IN 3883

7 October 1963

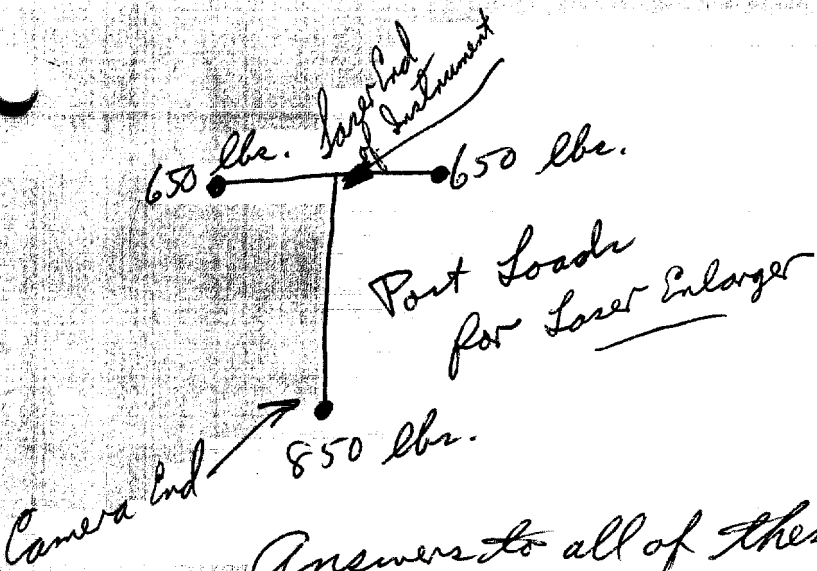
1. (A) TENTATIVE SUPPORT POST LOADS AND LOCATION: POSTS LIE AT ENDS OF CAPITAL LETTER T; 850 LBS AT BASE OF T; T HEIGHT IS 60 INCHES; 650 LBS AT EACH END OF TOP OF T; T TOP WIDTH IS 36 INCHES.
 (B) PLAN LABEL END OF INSTRUMENT AT TOP OF T. THIS IS CHANGE FROM SCHEMATIC 581-9883.

(C) WHAT IS LATEST DATE TO FURNISH YOU WITH FINAL POST LOCATIONS AND TOLERANCES?

The following schematic is appended after reading message. We still require the height above the floor, so that we can determine how much of the concrete posts (or granite posts) is required to add to the steel posts in order that the instrument be of the proper operating height. When we have this, we can determine the additional weight of the concrete (or granite) and so determine the floor loading.
